0-3-79	2	ADDENDUM II	LBV
8-24-79	1	GUNITE ON WALLS ONLY	LBG
DATE	REV.	DESCRIPTION	BY
08/23/79	1	GUNITE REPAIR AS SHOWN	LBG
08/23/79	1	CARVINS COVE FILTER	LBG
08/23/79	1	PLANT - I-81 NORTH	LBG
08/23/79	1	ROANOKE, VIRGINIA	LBG
08/23/79	1	CITY OF ROANOKE	LBG
08/23/79	1	STATE OF VIRGINIA	LBG
08/23/79	1	CONTRACTOR MUST VERIFY ALL DIMENSIONS AT PROJECT BEFORE PROCEEDING WITH WORK	LBG

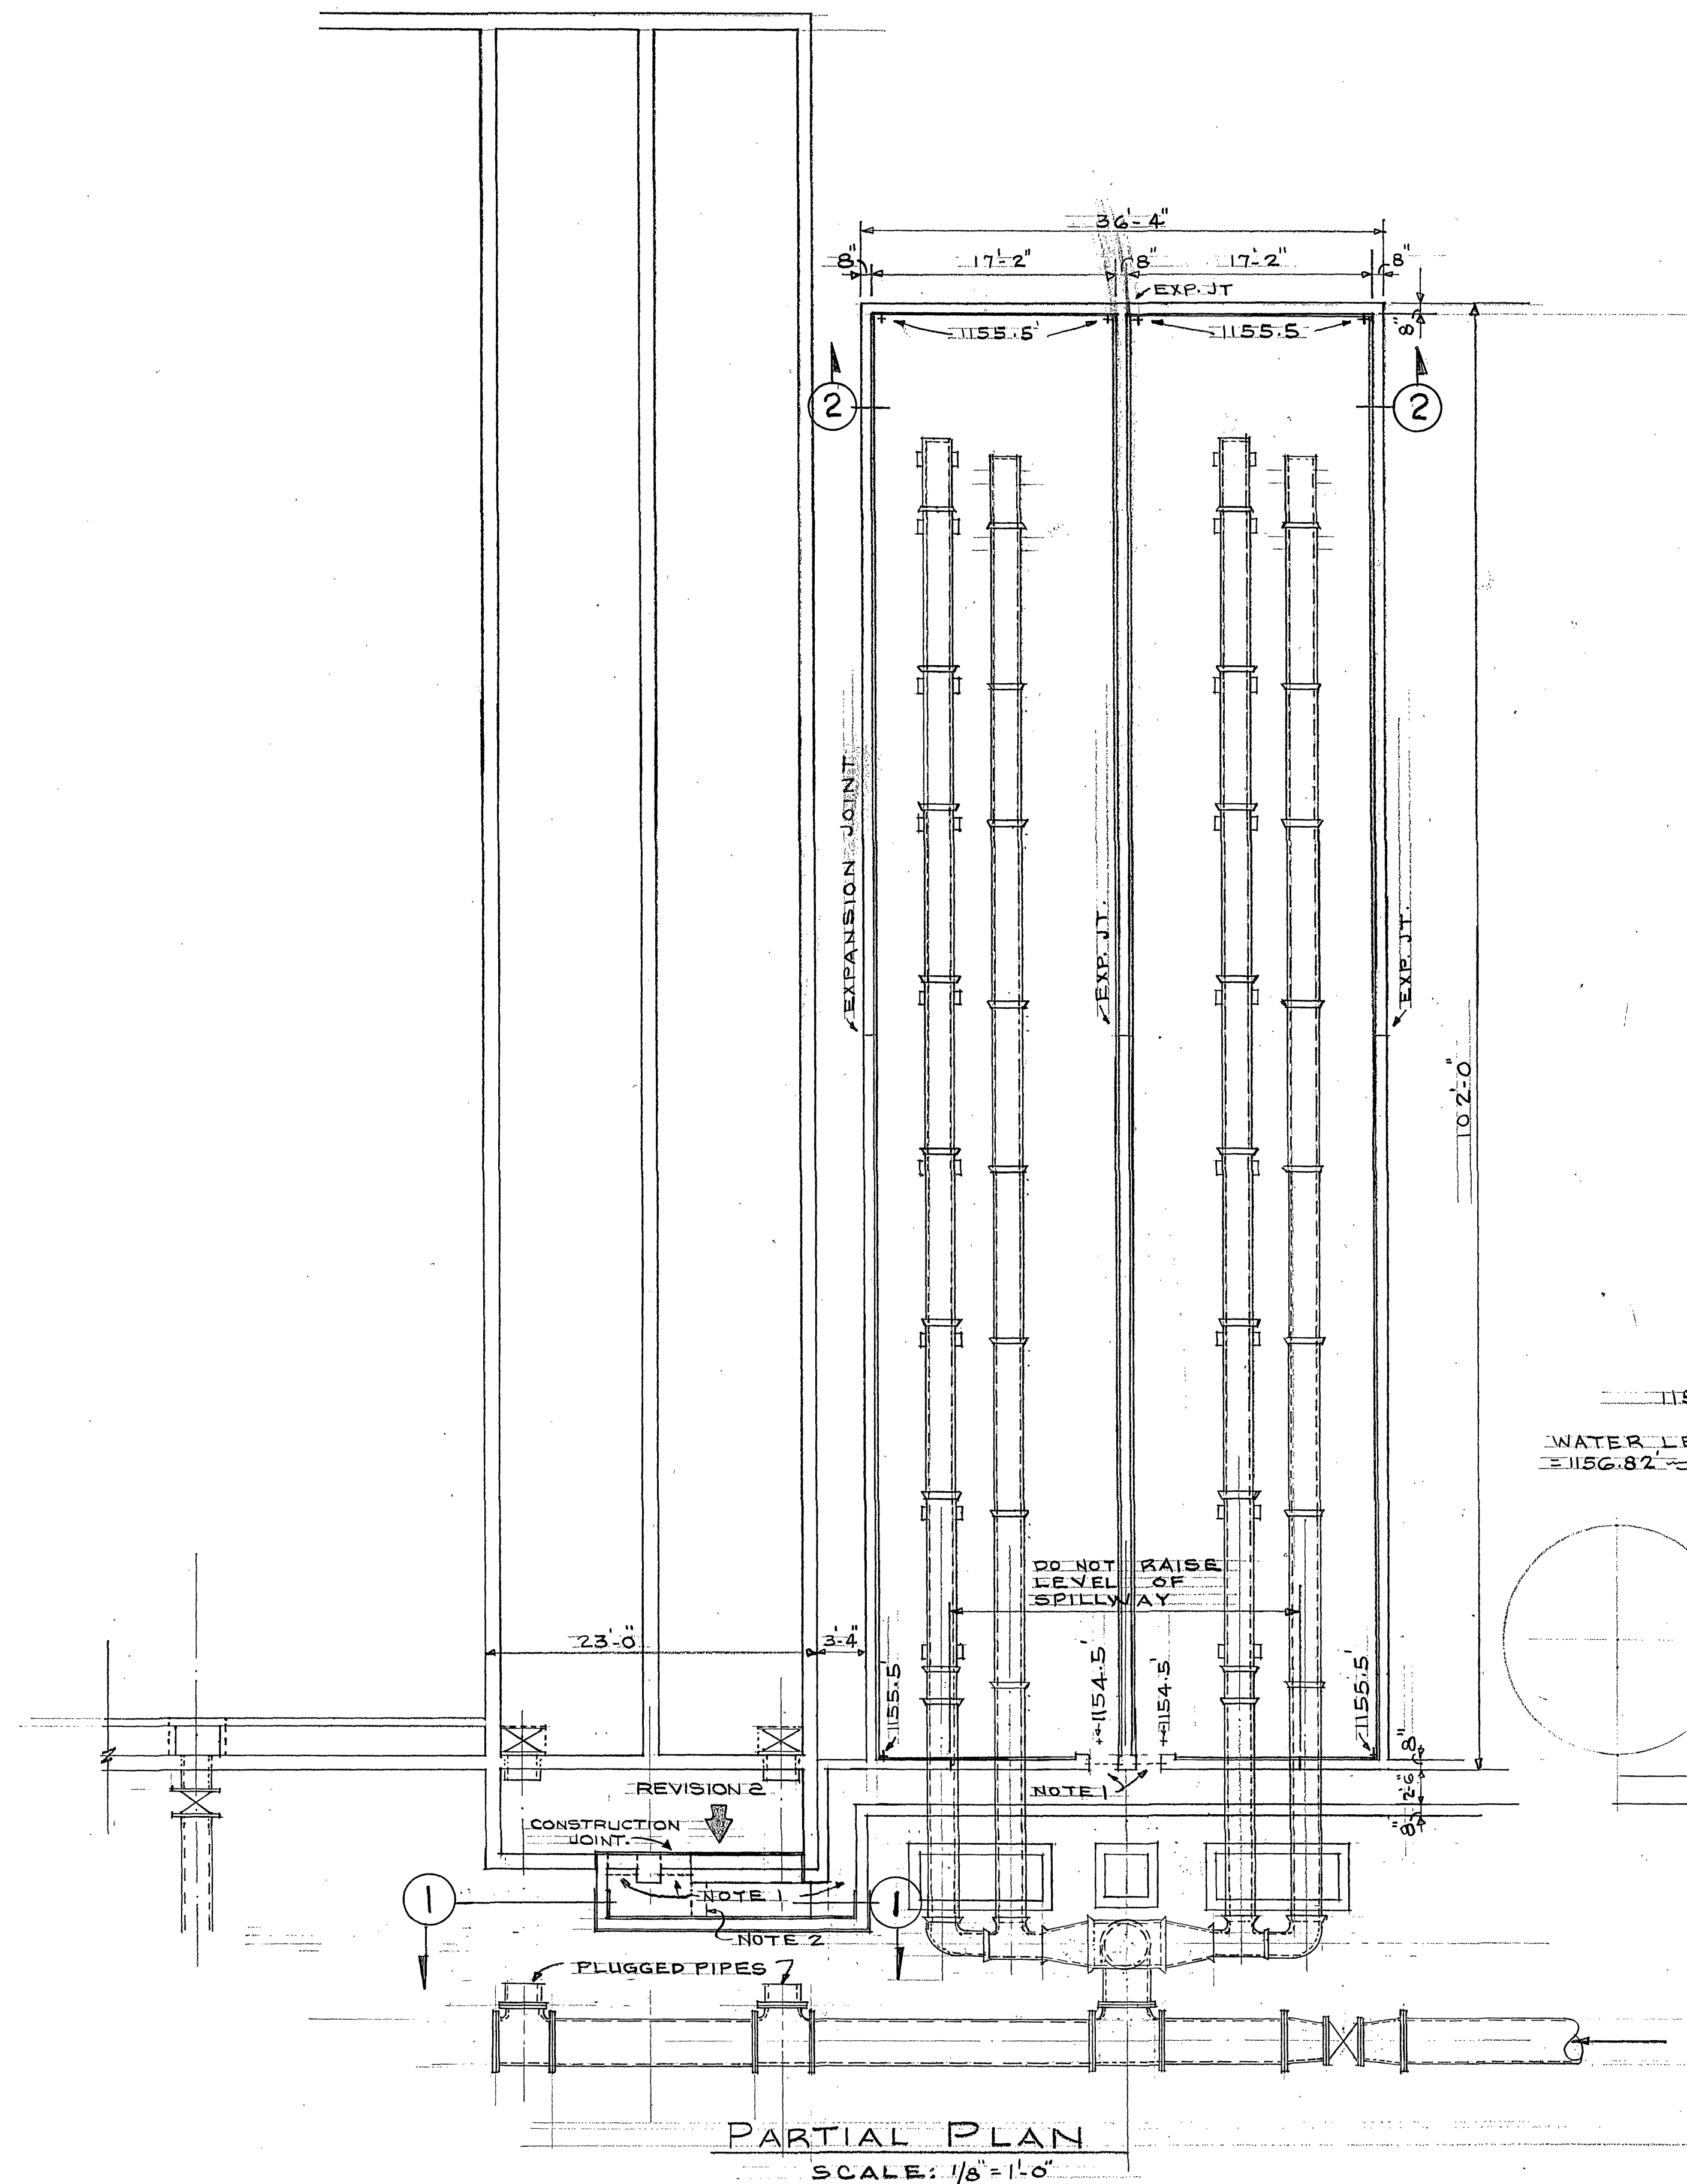
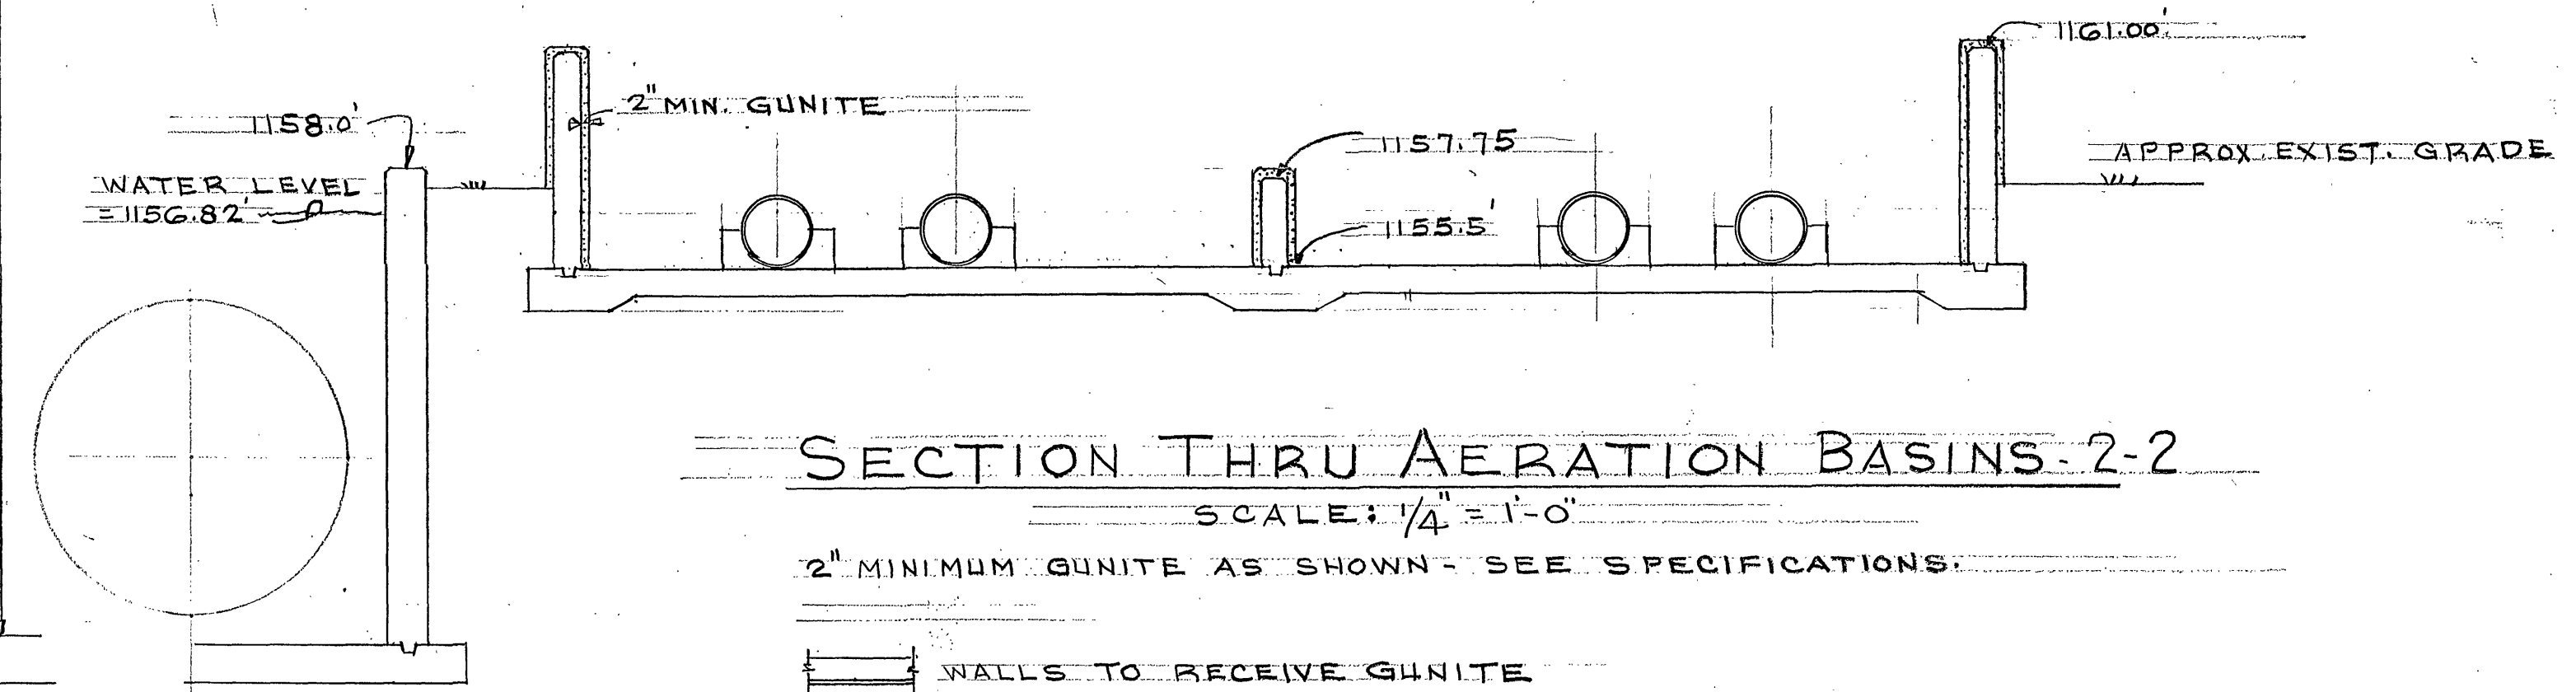
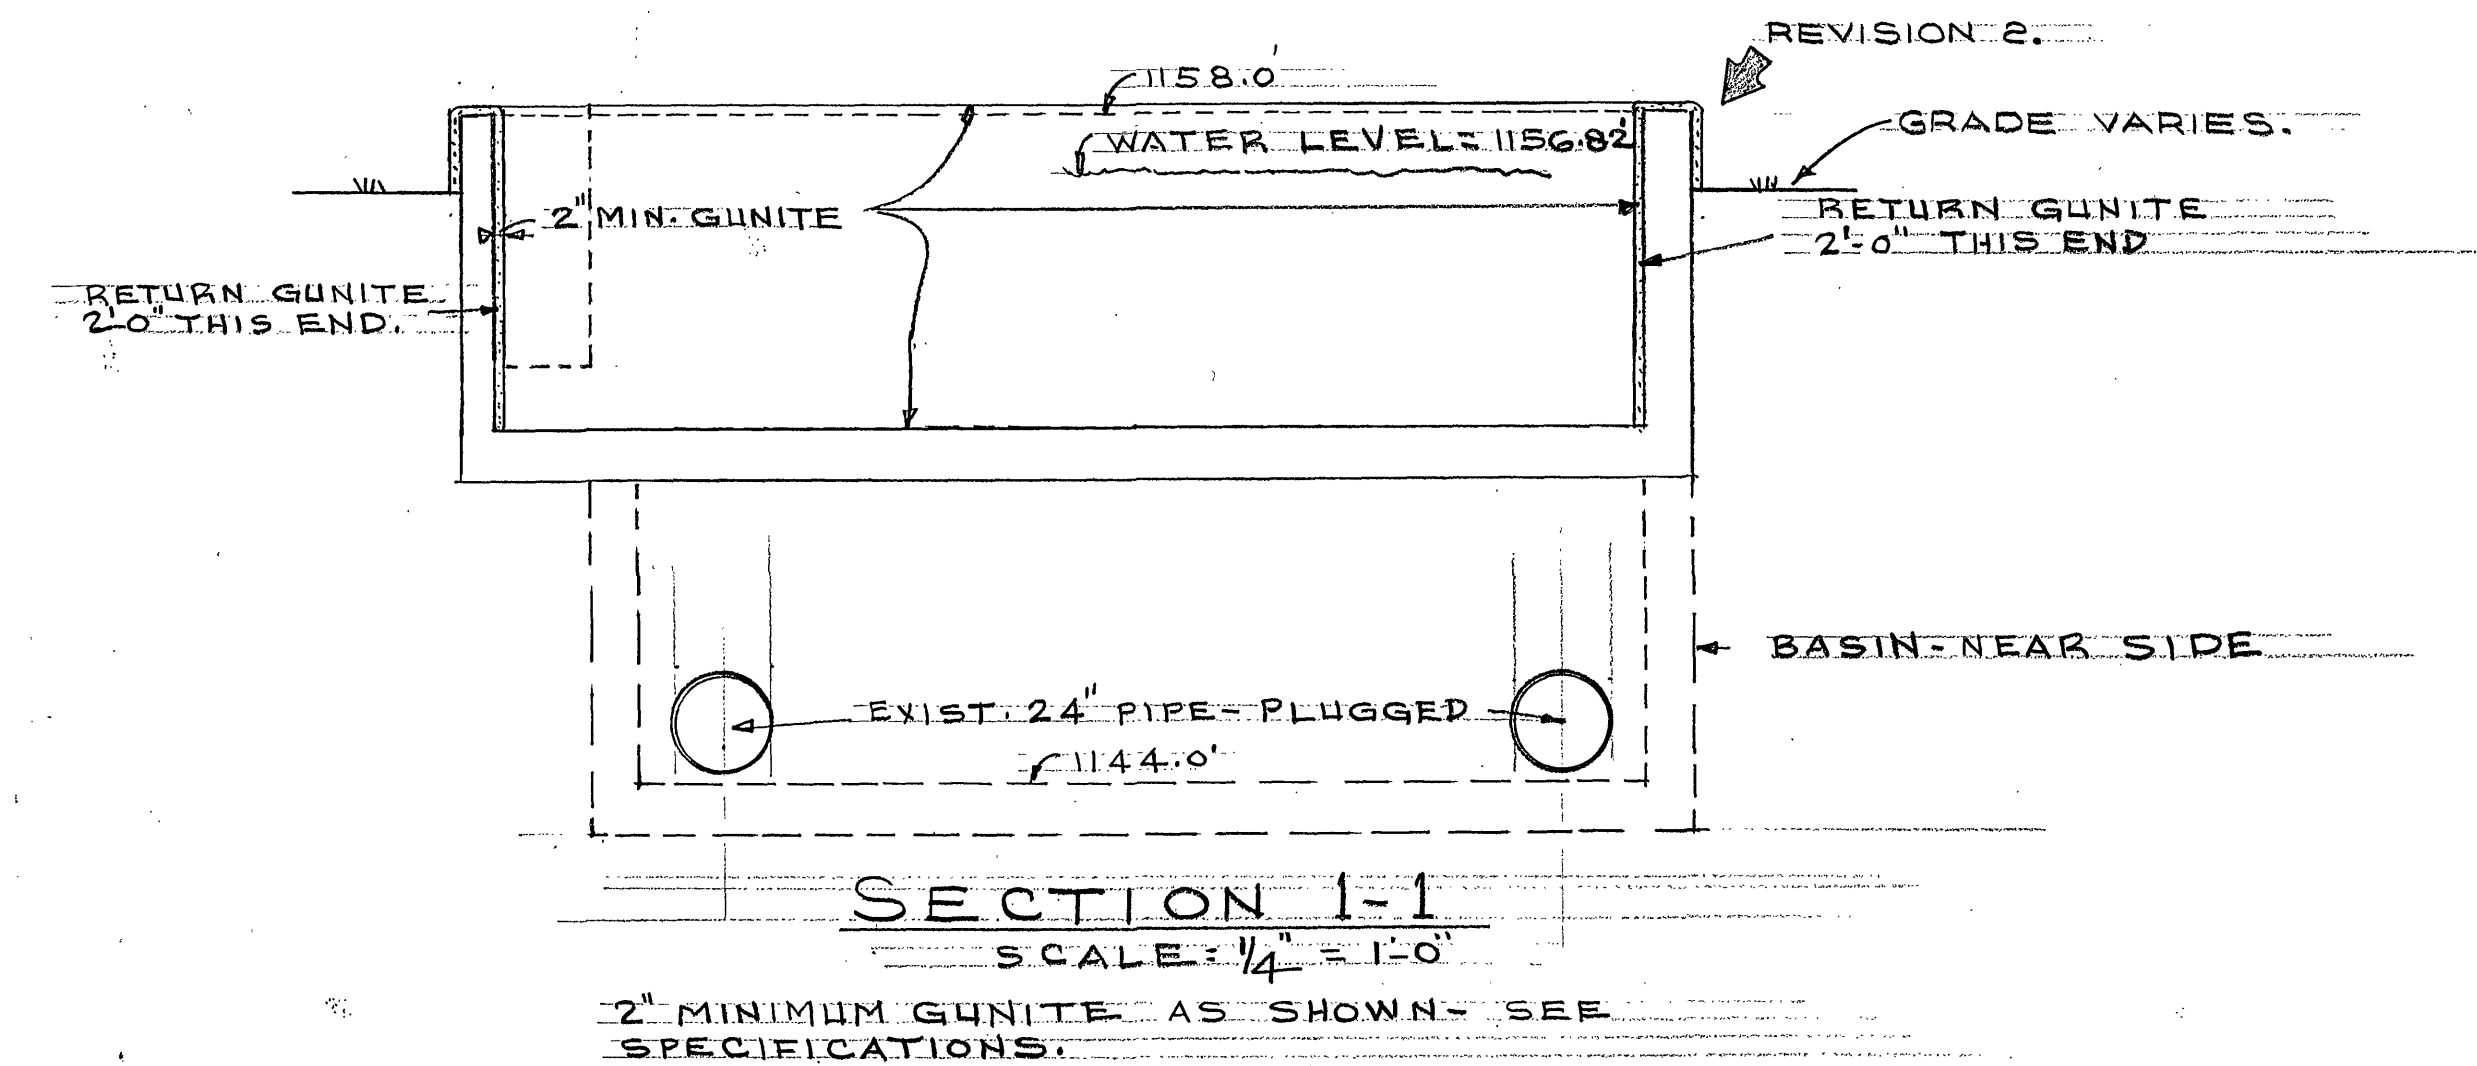
NOTE 1.
CONCRETE IN PASSAGEWAYS HAS
SPALLED BADLY AND IS IN DIRE
NEED OF REPAIR. RETAIN AS MUCH
OF ORIGINAL PASSAGE OPENING WIDTH
AS POSSIBLE.

NOTE 2.
BEAM OVER IS 12 1/2" W x 8" D. RETAIN REINF.
& REBUILD CONCRETE PORTION OF
BEAM.
